**ADDENDUM #2**

PROJECT: LCAP Pre-K Playground Project – Weber Institute  
Stockton Unified School District

REF. # : ARCH PROJ. No. 2023-16  
DSA FILE # 39-H7  
DSA APPL. 02-122466  
PTN: 68676-278

DATE : September 4, 2024

1 IRRIGATION PLAN 1/4" = 1'-0"

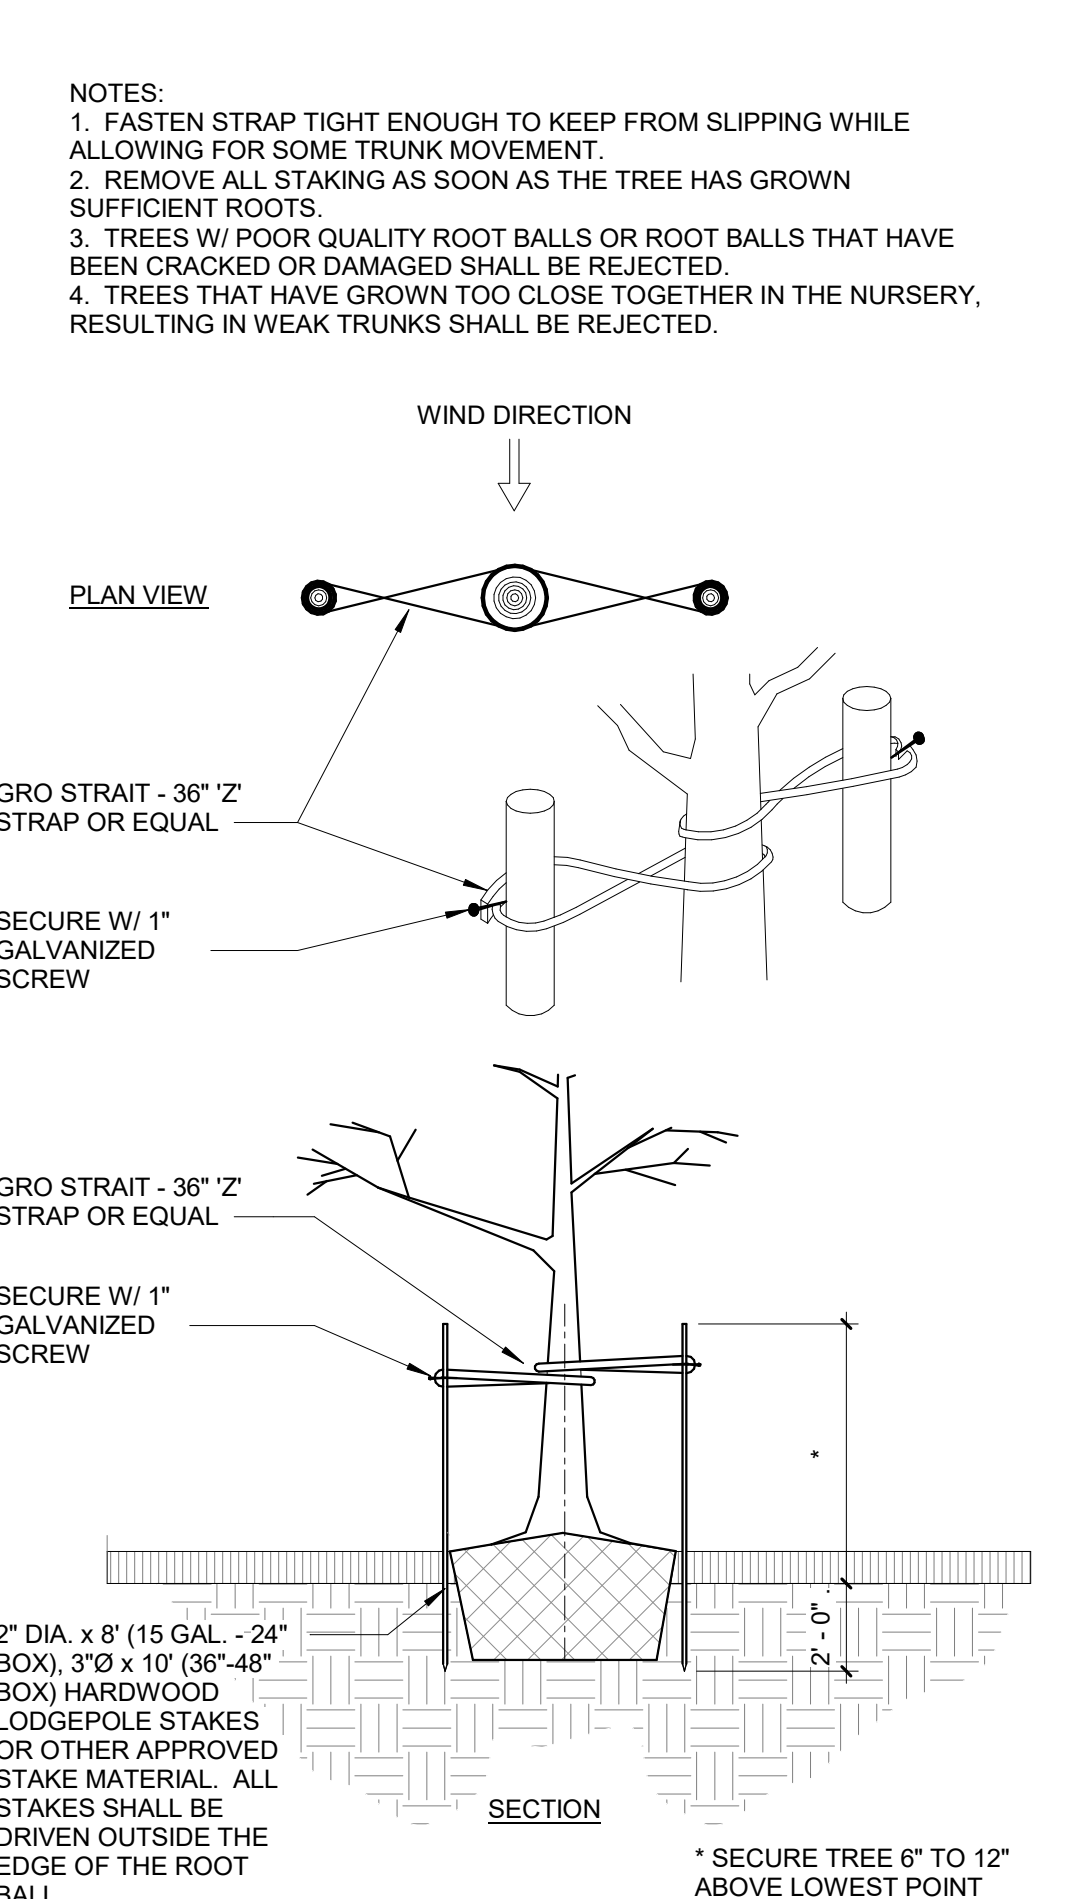
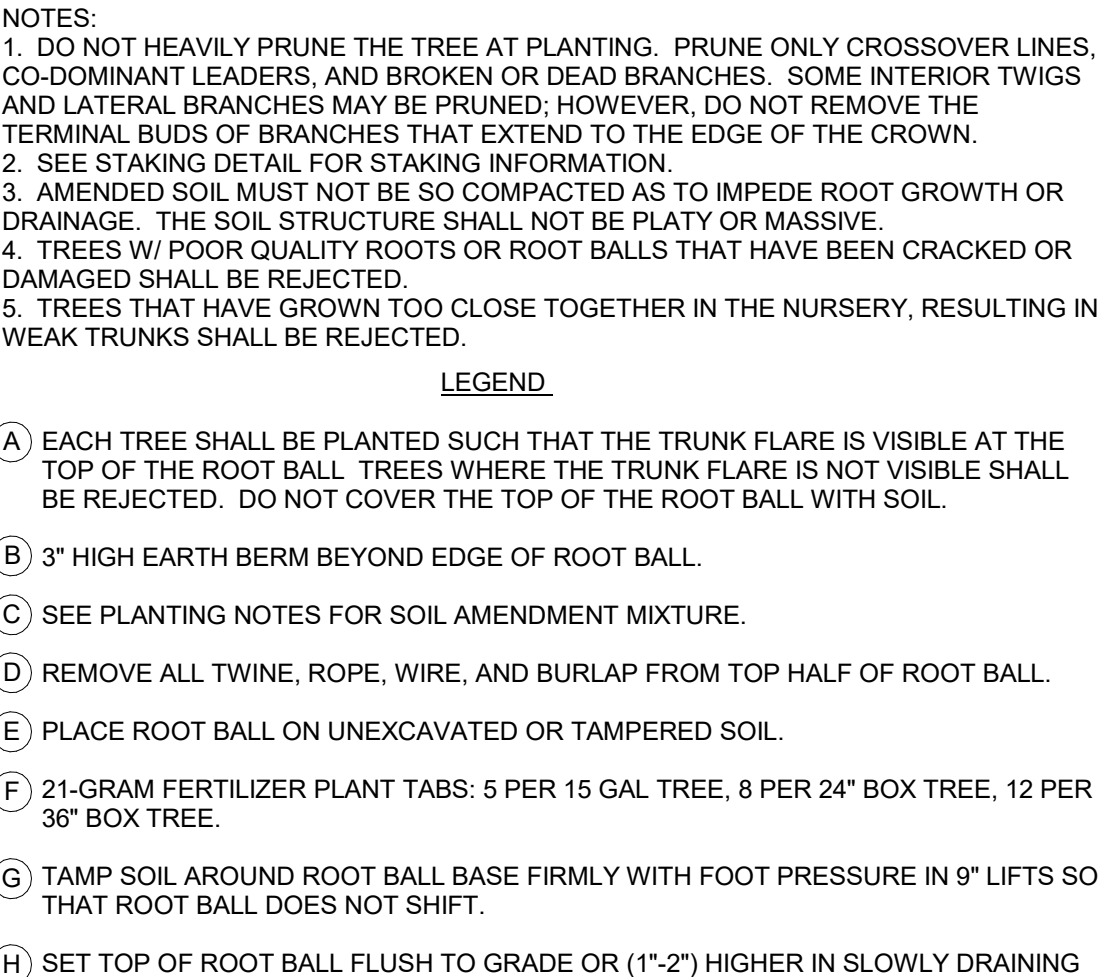
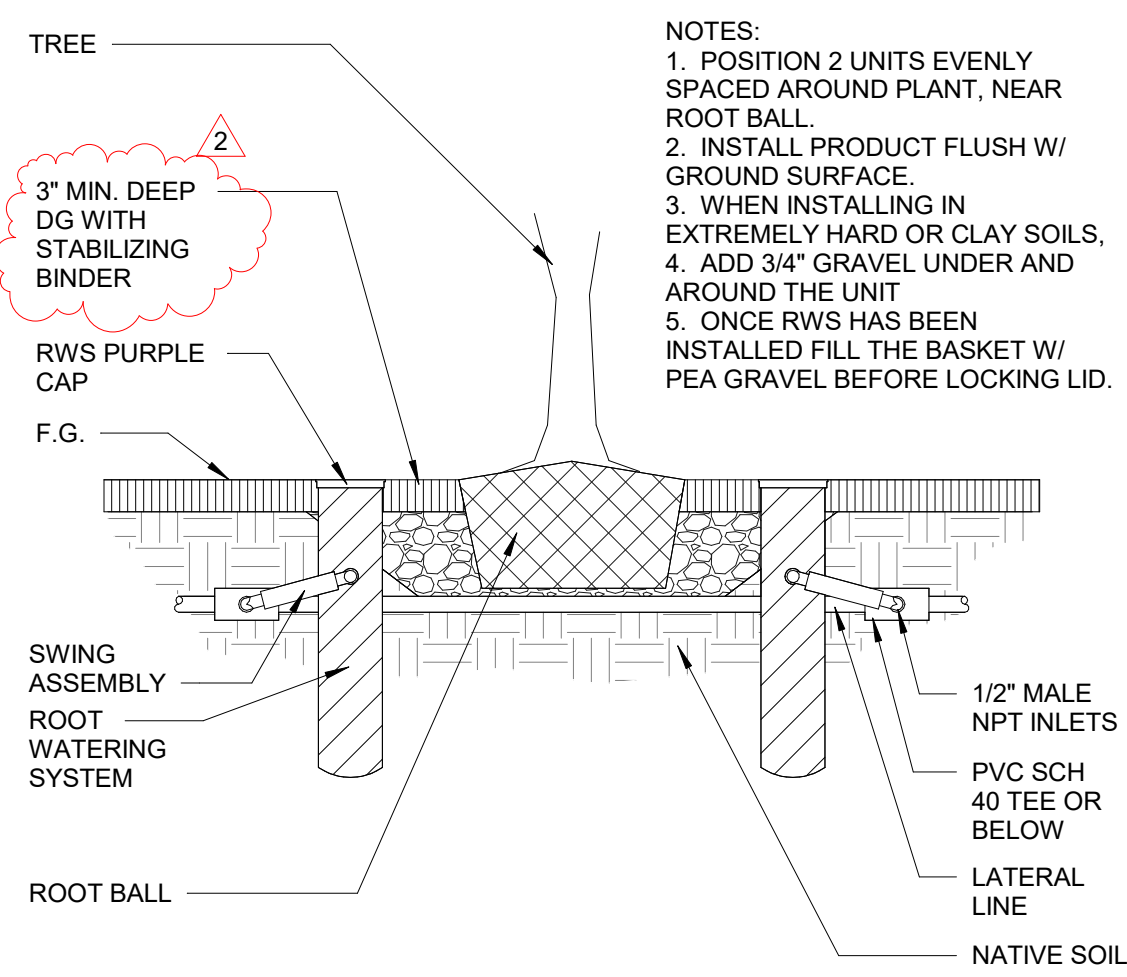
Refer to sheet A1.6 in the DSA approved plans.

Make modifications to the existing irrigation system as shown on attached sheet A1.6.

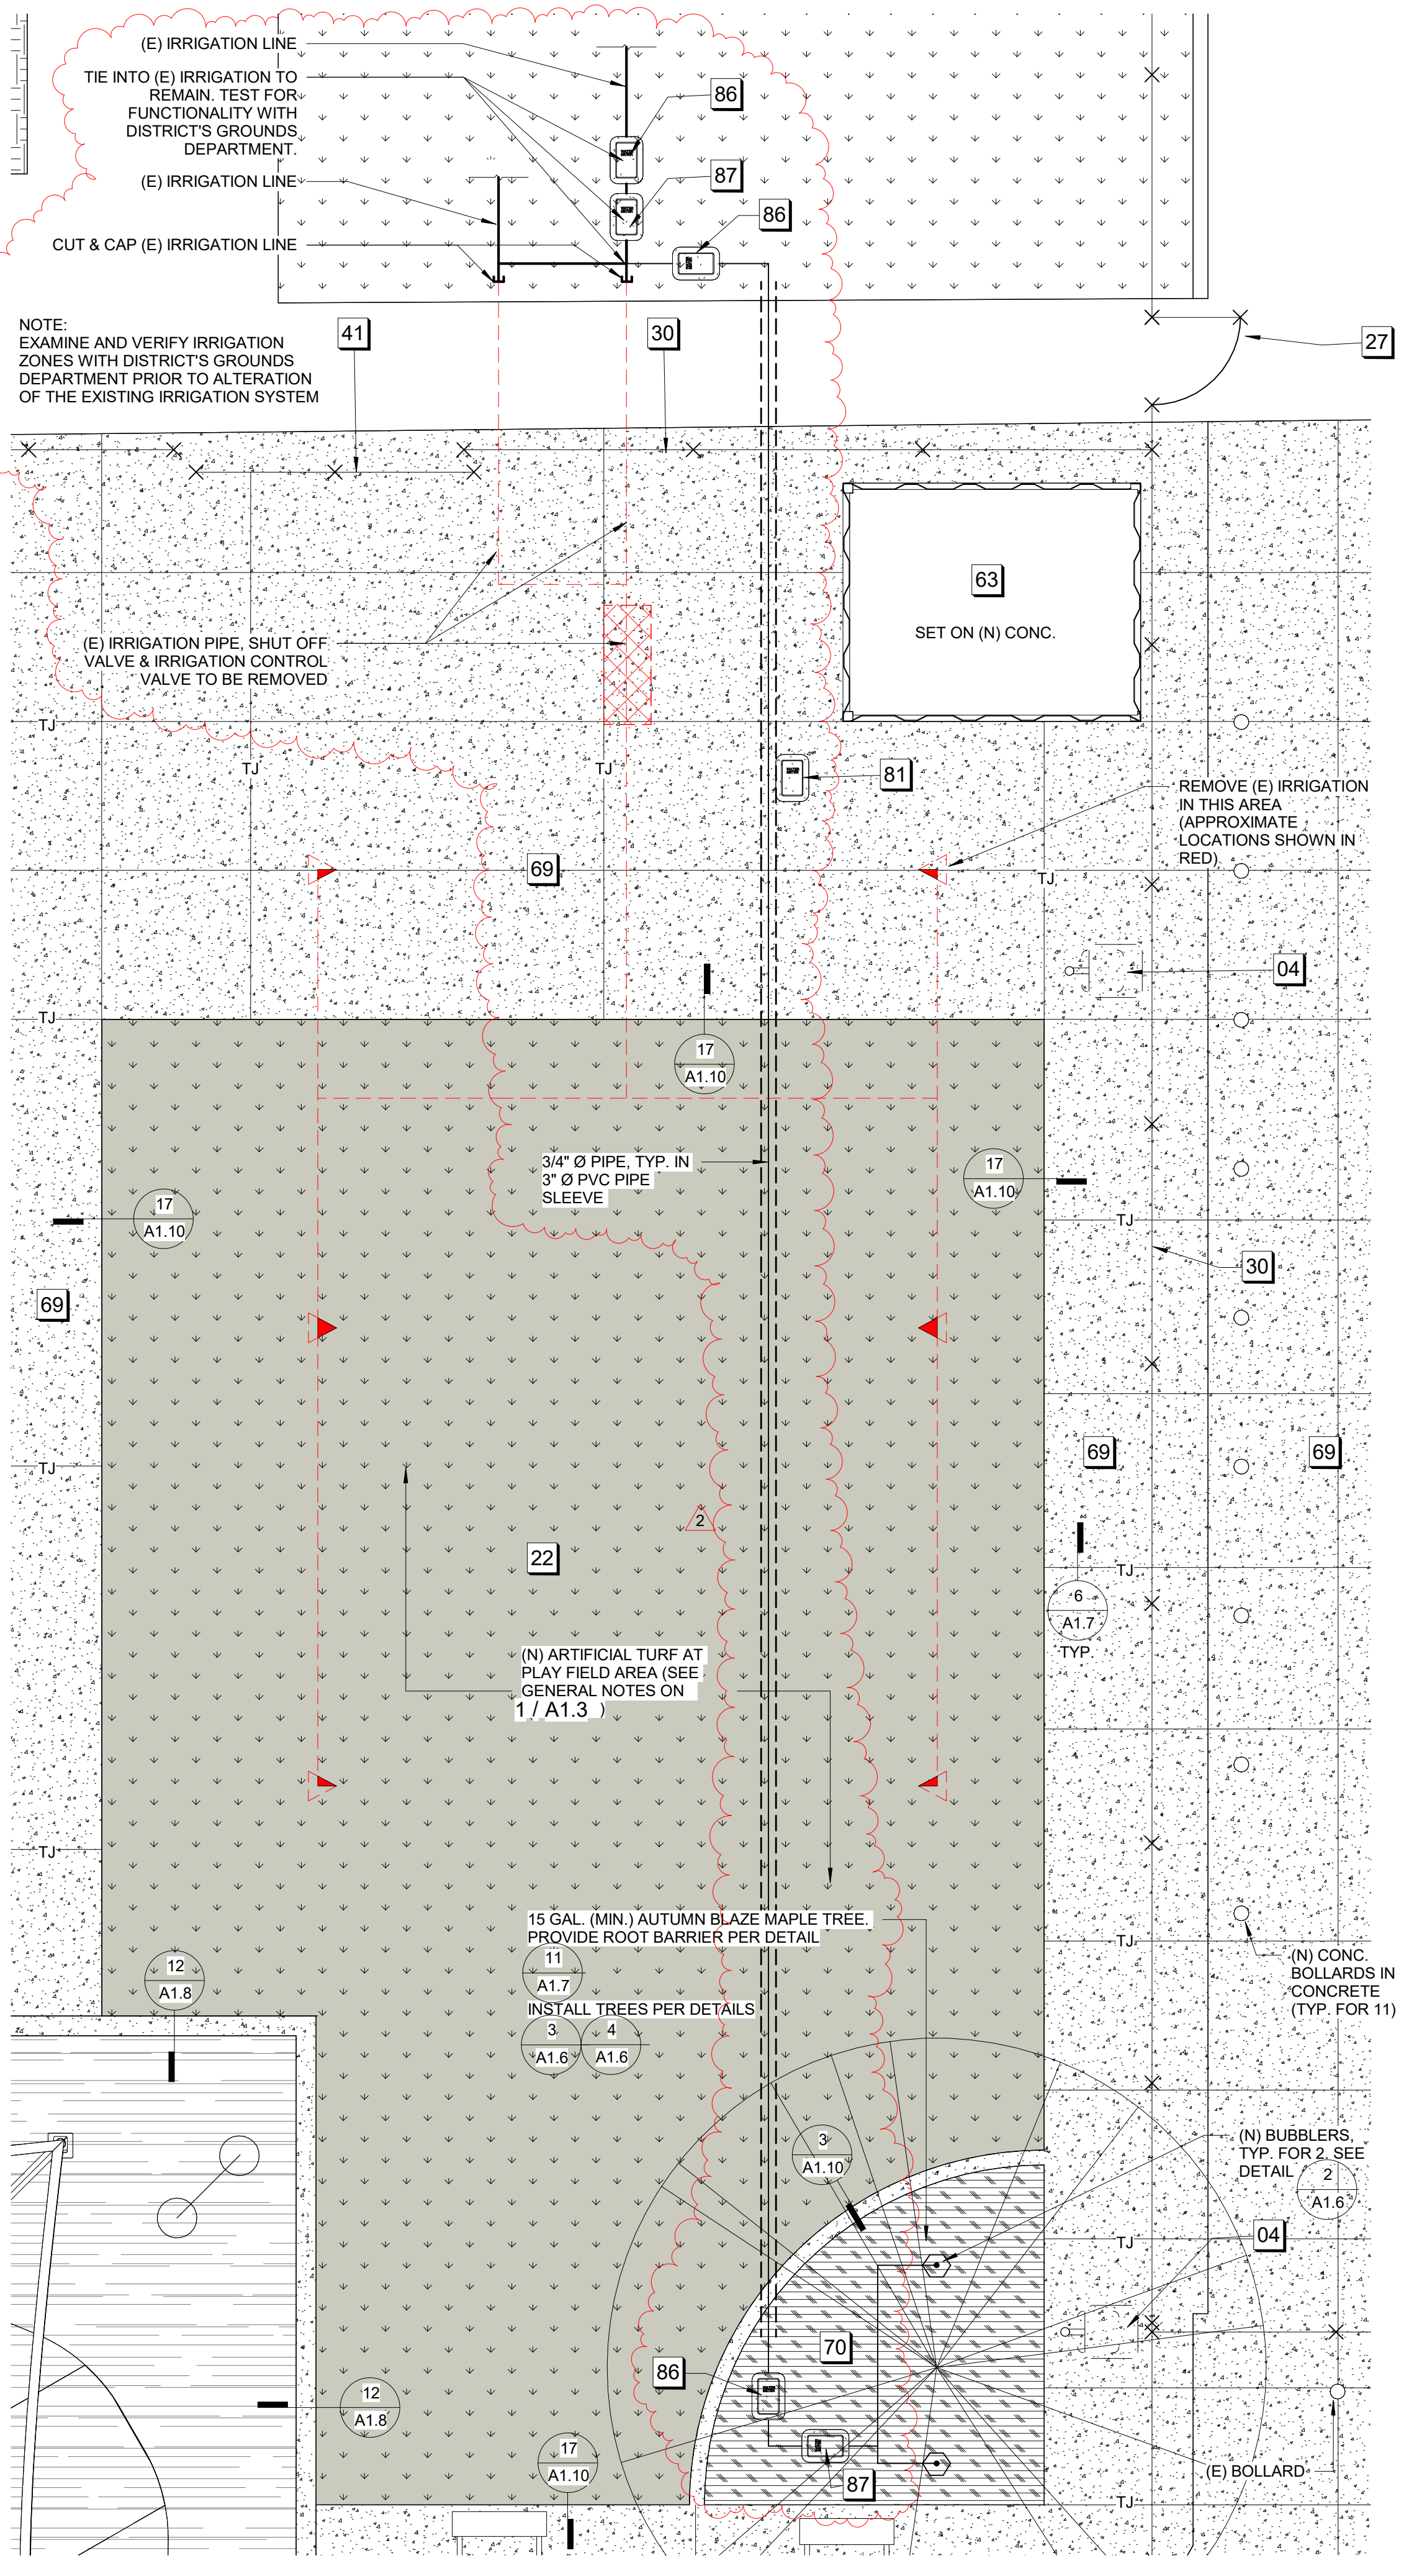
Change thickness from 2 inches minimum mentioned in Addendum #1 to 3 inches minimum.

Details 2 & 4 on attached sheet A1.6 and Detail 11 on sheet A1.7, have been revised to show the DG installation at the tree locations.
